This document is not an ASTM standard and is intended only to provide the user of an ASTM standard an indication of what changes have been made to the previous version. Because it may not be technically possible to adequately depict all changes accurately, ASTM recommends that users consult prior editions as appropriate. In all cases only the current version of the standard as published by ASTM is to be considered the official document.

Designation: D 3117 – 03

Standard Test Method for Wax Appearance Point of Distillate Fuels¹

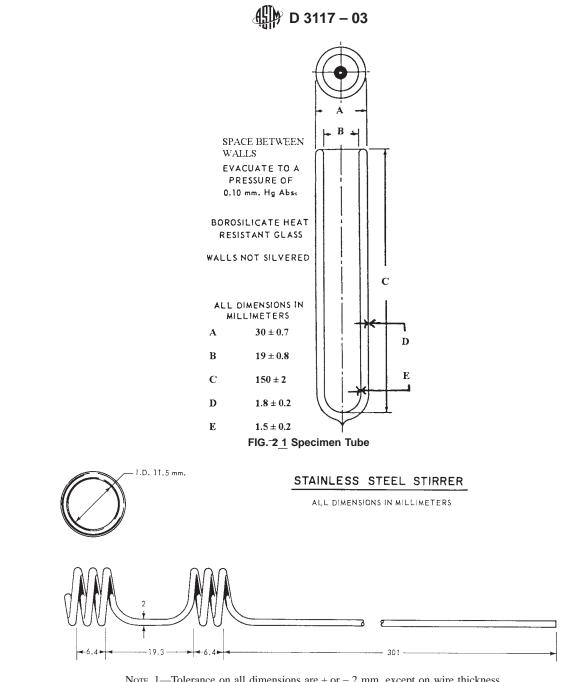
6.1 Specimen Tube—A double-walled (Dewar-type) jacketed tube with dimensions shown in Fig.-2_1.

6.3 *Stirrer Assembly*—A stainless steel wire configured in the manner described in Fig. <u>3.2</u> and manipulated by a motor or other suitable device in a vertical direction. The frequency of movement shall be 55 ± 5 cycles/min with an amplitude of 50 ± 5 mm. The stirrer shall be concentric with the <u>thermometer temperature measuring device</u> and shall be fitted with the moisture proof collar specified in Test Method D 2386. A No. 3, two-hole neoprene rubber stopper shall be used to seal the top of the specimen tube.

FIG. 1 3 Complete Assembly

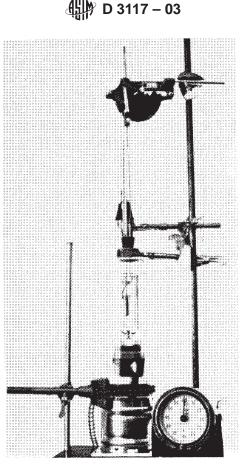
8.3 Assemble the unit as shown in Fig.-1.-3.
